HIBSER YAMAUCHI Architects, Inc.

May 2, 2019  
Rev May 9, 2019

Re: San Pedro Elementary School  
Additional Services Fee Proposal for  
Scope Reduction

1 CAMPUS PLAN

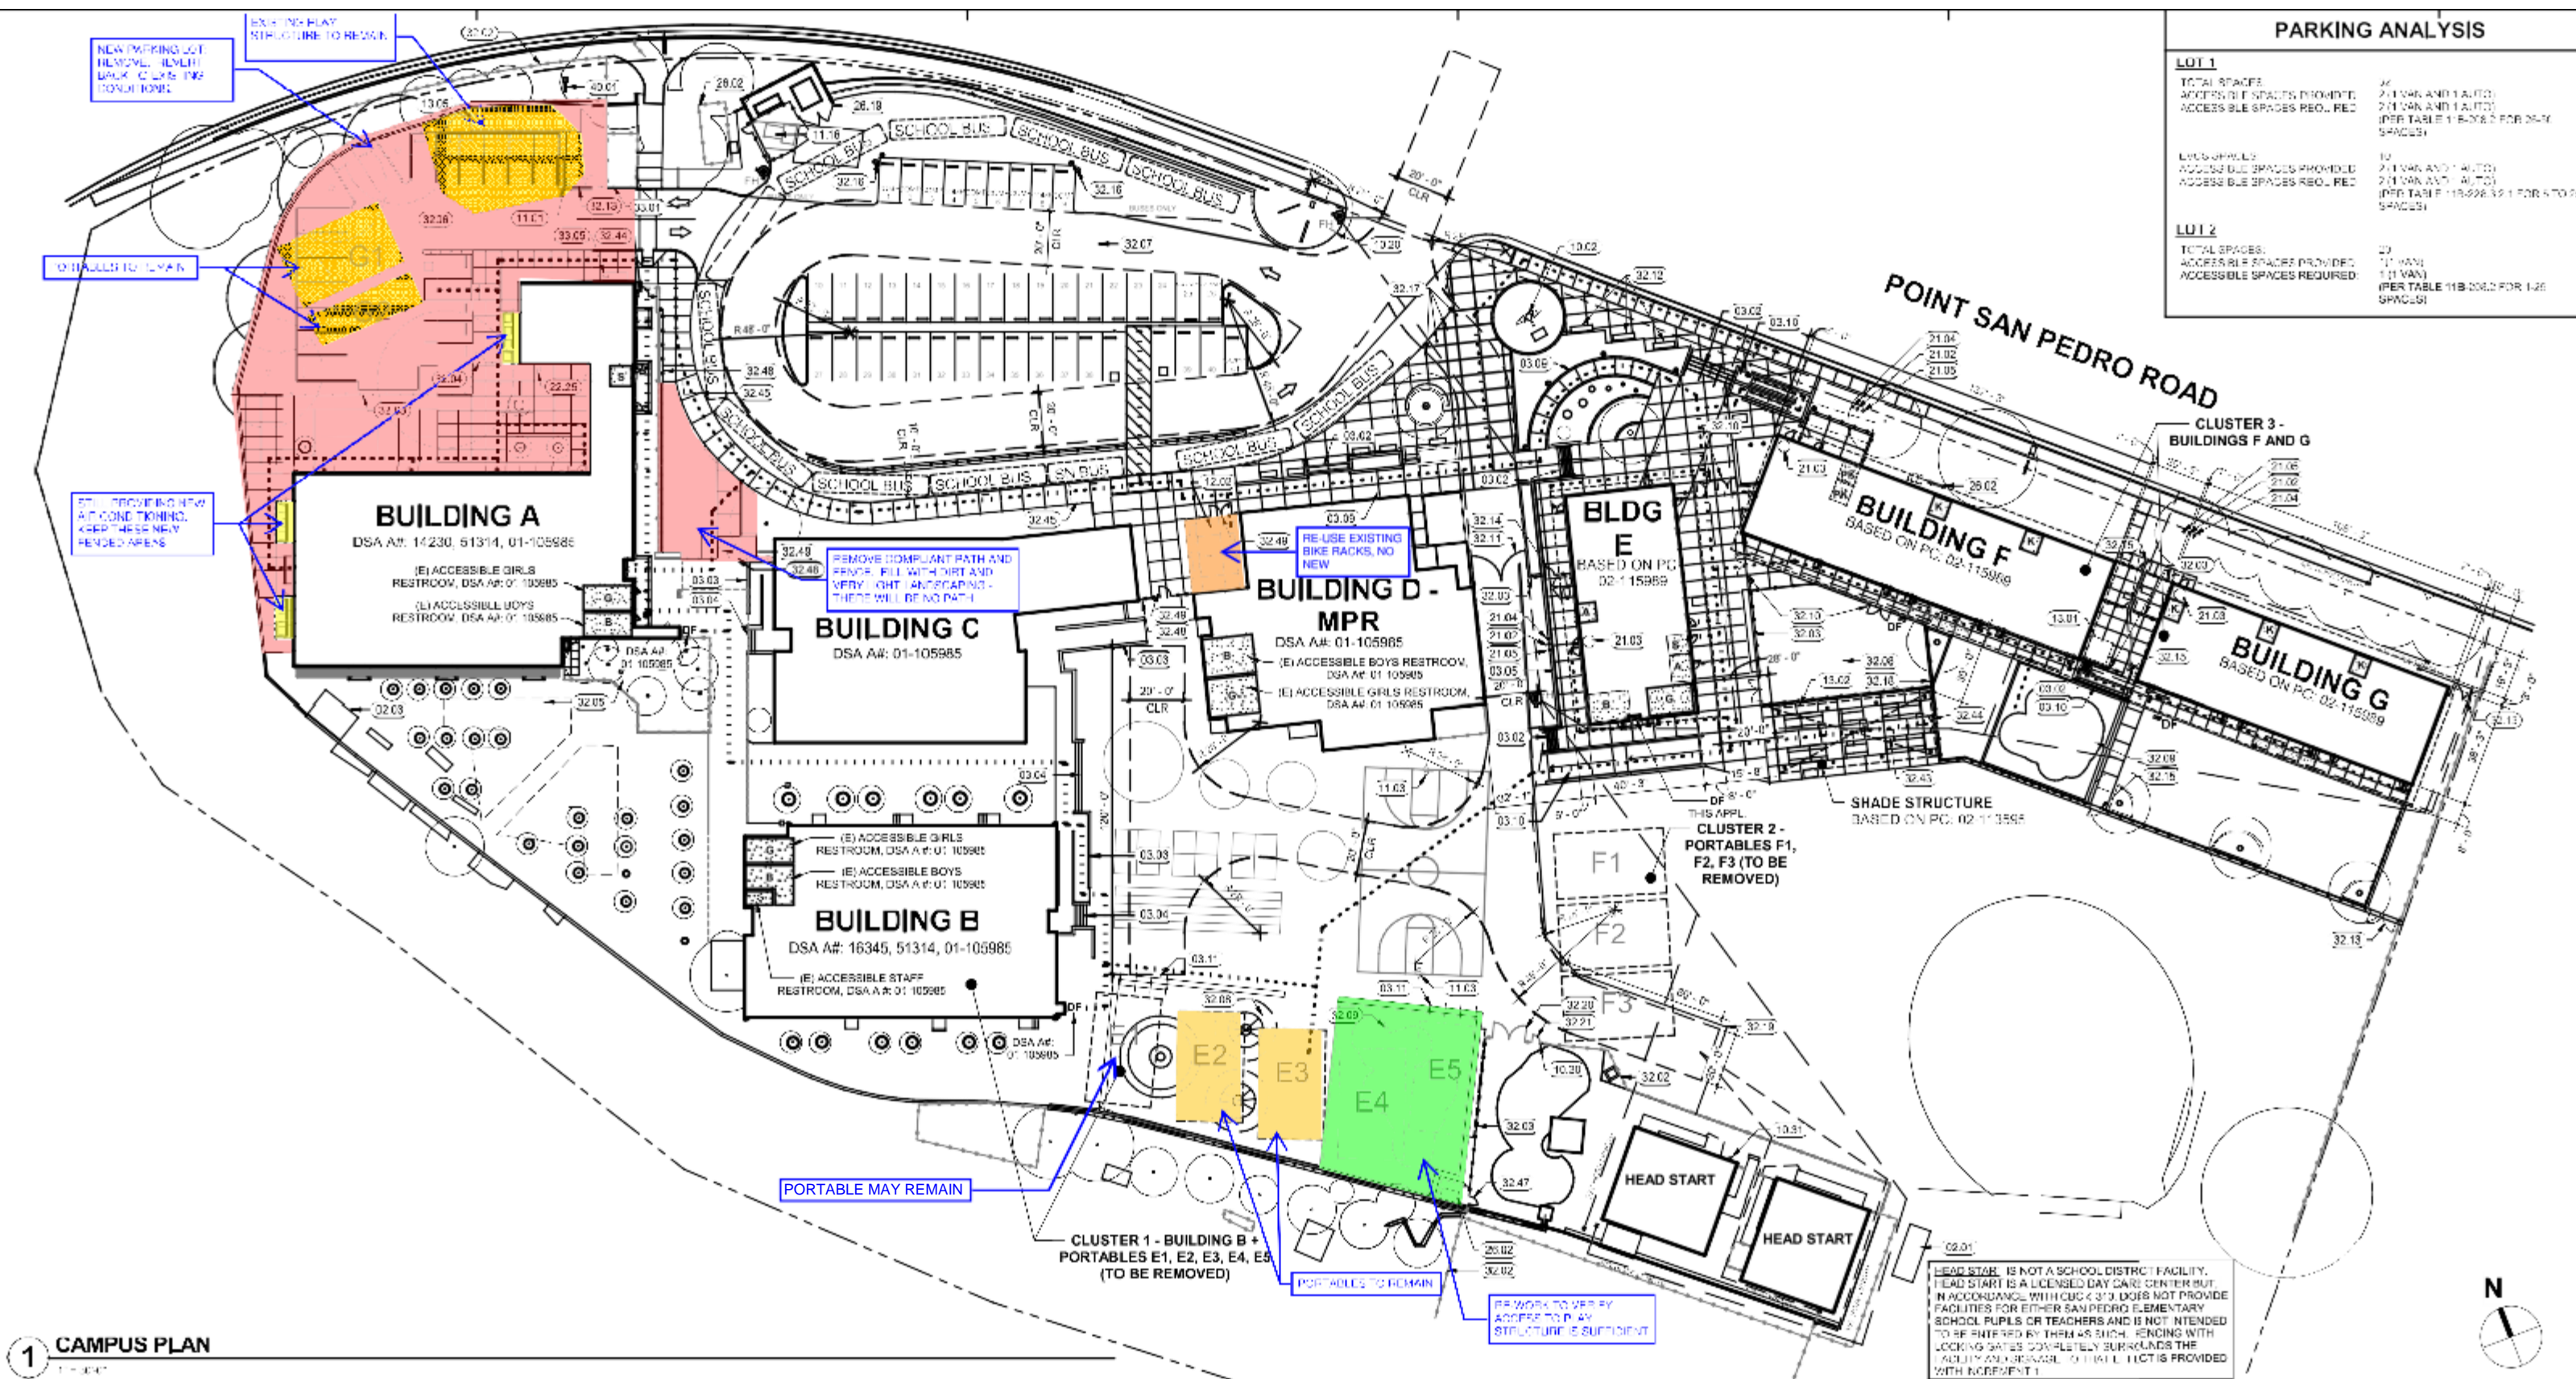
- Eliminate the rear parking and plaza area from the scope of work.
  - o The existing paving, landscaping, underground utilities including electrical conduit shall remain as-is. The two portables in this area and the play structure and safety surfacing shall also remain. The only exceptions are as follows:

- o Keep the three housekeeping pads for the new condensing units and fences; also to remain is the underground refrigerant lines serving these new units. This will require trenching and AC patching

- o Provide rubber landings at the existing classroom doors
  - o The old electrical MSB near the existing gate will be removed as part of the electrical service upgrade.

- Minimize the scope of the improvements between Buildings A and C. This includes:
  - o Removal of the existing AC and brick paving from the sidewalk to a line parallel with the walkway roof.

- o Provide a new, minimal landscaping and irrigation design.
  - o Provide an 8'-0" high chain link fence as additive alternate #1. This fence shall extend between Buildings B and C, in front of the covered walkway; a second segment shall extend along Building A's covered walk and shall include a gate near the existing Kindergarten classroom door.

- Minimize work in the Bike rack area: The District will provide the racks.
- Reduce the scope of the work in the main playground:
  - o Keep Portables E2 and E3 (Rooms 302 and 303) in place and operational. Portable E1 (Room 301), shall be removed by Mobile Modular; if the District can reach an agreement with the vendor, E1 may remain in place. Either way, the existing AC paving shall remain as is. The electrical, low voltage and fire alarm systems will be modified to include these

portables. The electrical work is significant because the fire alarm panel and the annunciator have to be relocated to Building E for code reasons. The line voltage systems will be modified to work with the new panels.

- The new play area shall be reduced to only include the new play structure and related safety surfacing. The ball walls and tether ball courts will be removed.
- The revised finish grades and slopes in this area need to be reviewed with some care to provide code compliance for ADA path of travel and drainage.
